Client	: SCOTIA GAS NETWORKS
Project Title	: BRAISHFIELD "B" MEASUREMENT ERROR REVIEW
Document Title	: FURTHER RESPONSES to TECHNICAL QUALIFICATIONS RECEIVED on the DRAFT (SMER) REPORT
Document Ref.	: NK3173 – 005
Client Ref.	: S000114052010

This document details the responses of the Appointed Independent Technical Expert (ITE) to further Technical Qualifications submitted by British Gas (09/02/11) in reference to the Braishfield "B" SMER Draft Report (KELTON[®] report reference NK3173-003) dated 22/11/2010 and the associated discussions within the JO meeting of 25th January 2011.

Figure 1

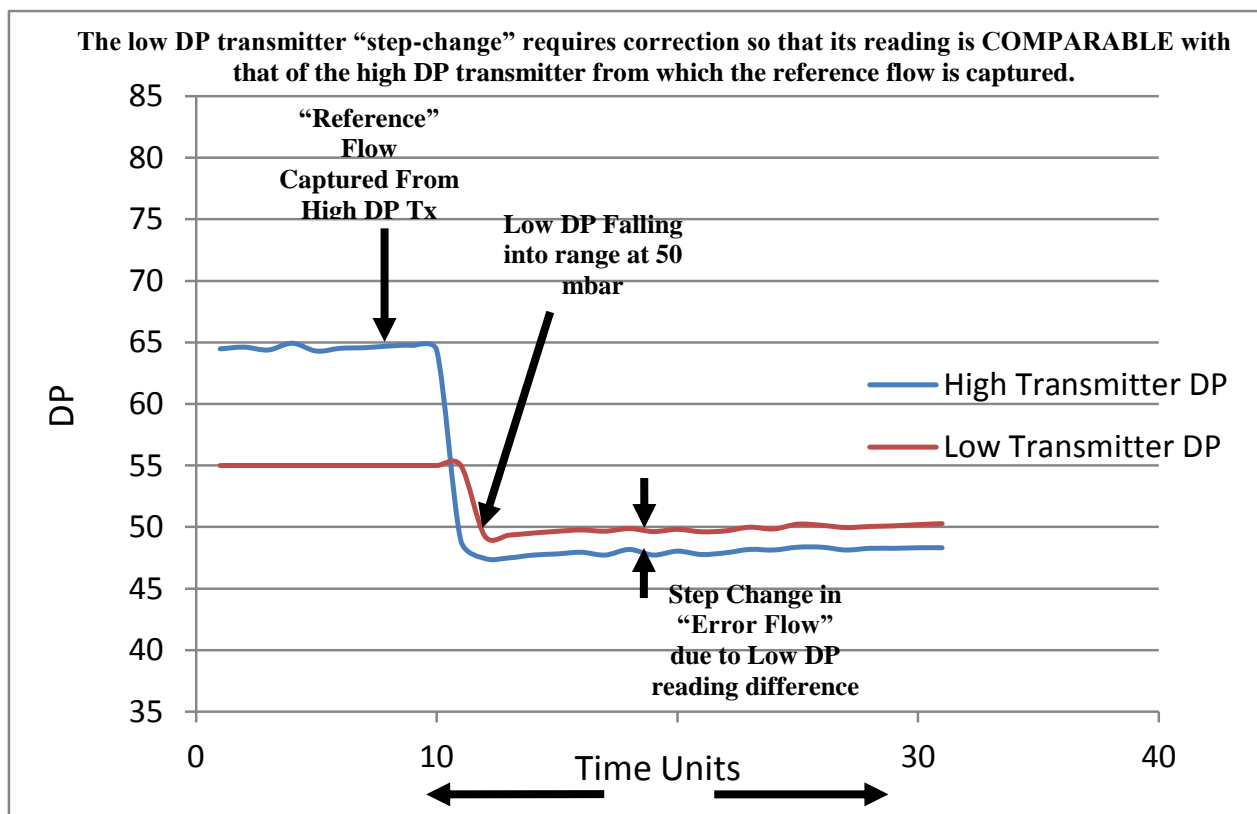
There is a duty High DP and Standby High DP cell together with a low DP cell. With the discrepancy at Low DP, surely priority should be given to the low DP when it is operating in its range. The DP at low flows is given and will be within the range of the low DP cell with recorded DP's of 20 to 60 mbar and the Low DP cell range 0 – 50 mbar. Can you please advise what reason is there for using the high DP cell for such low readings? It was stated that as there are two readings it is not known which is correct. The fact that the Low DP cell gave a step change in the error should not be dismissed as being incorrect, especially if the DP cell was within its ME2 tolerance. It could be that the high DP cell was in error over its whole range. We would appreciate your view on this.

FURTHER ITE RESPONSE: THIS IS VERY SIMILAR ISSUE TO THAT REFERENCED IN POINT 11 (ANSWERED PREVIOUSLY) & HOPEFULLY THE ITE RESPONSE ASSISTS IN THE UNDERSTANDING HERE.

AS THE MAIN POINT OF TESTING IS TO DERIVE THE "DIFFERENCE" BETWEEN THE REFERENCE FLOW & THAT OF THE OPEN EQUALISING VALVE FLOW (ERROR FLOW) THE 2 READINGS MUST BE COMPARABLE TO FULLY REFLECT THE MAGNITUDE OF THE TRUE ERROR DIFFERENCE.

DURING THE HIGH & MEDIUM FLOW TESTING, THE FLOW WAS DERIVED FROM THE OUTPUT OF THE HIGH RANGE TRANSMITTER THROUGHOUT THE ENTIRE FLOW RANGE, SO NO STEP CHANGE IS INTRODUCED BY HIGH/LOW TRANSMITTER CHANGE-OVER EFFECTS DURING TESTING.

HOWEVER AS SHOWN IN FIGURE 1 BELOW, THE LOW FLOW TESTING WAS DIFFERENT IN THAT THE LOW DP TRANSMITTER OUTPUT WAS SELECTED BY THE OMNI (AT <50 mbar) AND THEREFORE CREATED A "STEP CHANGE" IN THE COMPARED "ERROR FLOW" (DERIVED FROM THE LOW DP TRANSMITTER) & THE REFERENCE FLOW (DERIVED FROM THE HIGH DP TRANSMITTER). AS THIS DID NOT REFLECT THE TRUE DIFFERENCE BETWEEN THE FLOW RATES, A CORRECTION WAS MADE TO THE LOW DP TRANSMITTER TO NEGATE THIS EFFECT FOR TEST PURPOSES ONLY.
